# Access Compliance Report

## Public Rights-of-Way

### (Curb Ramps)

Intersection ID: 49558	Main Street: STEEL_YARD_CT	Cross Street: WARREN_BURGESS_LN	Location: SW
ADA ID: 452C1E8C2105	Ramp Type: Perp	Initial Pass/Fail: Fail	Overall Compliance: No
Severity Score: 21.25			
Codes/Mitigation Info/Possible Solution		Field Measurements/Component Compliance

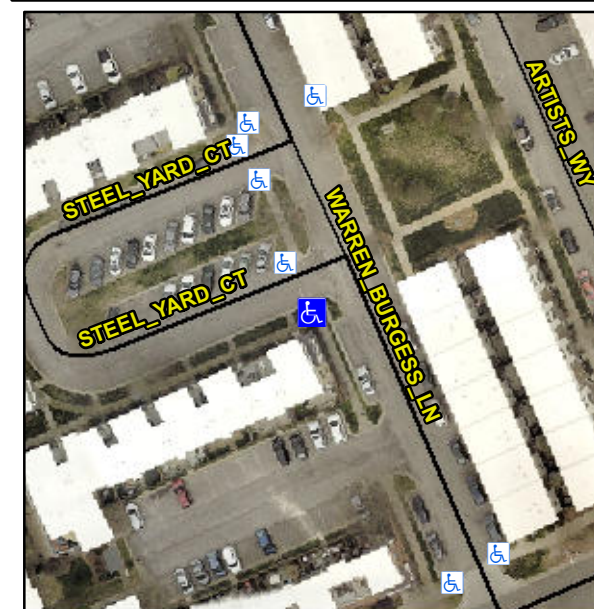
**Not Found, R304.5.1, R304.2.2**

Compliance	Description	Data	Compliance	Description	Data
N/A	Ramp Length (in)	71.0	No	Ramp Slope (%)	8.9
No	Ramp Width (in)	46.5	Yes	Ramp XSlope (%)	0.0
N/A	Flare Type LT	N/A	N/A	Flare Type RT	N/A
N/A	Flare Slope LT (%)	N/A	N/A	Flare Slope RT (%)	N/A
N/A	Flare Traversable LT?	N/A	N/A	Flare Traversable RT?	N/A
N/A	Landing Length (in)	N/A	N/A	DWS Provided?	N/A
N/A	Landing Width (in)	N/A	N/A	DWS Contrast?	N/A
N/A	Landing Slope (%)	N/A	N/A	DWS Length (in)	N/A
N/A	Landing X Slope (%)	N/A	N/A	DWS Full Width?	N/A
N/A	Landing Curb? (Y/N)	N/A	N/A	DWS Offset (in)	N/A
N/A	Shared Landing?	N/A			
N/A	Gutter Ponding?	N/A	N/A	Gutter Slope (%)	N/A
N/A	Gutter Lip Ht (in)	N/A	N/A	Gutter X Slope (%)	N/A
N/A	Painted X Walk1?	Yes	N/A	Painted X Walk2?	N/A
	X Walk 1 Direction	To N		X Walk 2 Direction	N/A
N/A	X Walk 1 Width (in)	51.0	N/A	X Walk 2 Width (in)	N/A
	X Walk 1 Slope (%)	2.1		X Walk 2 Slope (%)	N/A
	X Walk 1 X Slope (%)	1.5		X Walk 2 X Slope (%)	N/A

**Remove & Replace Entire Ramp.**
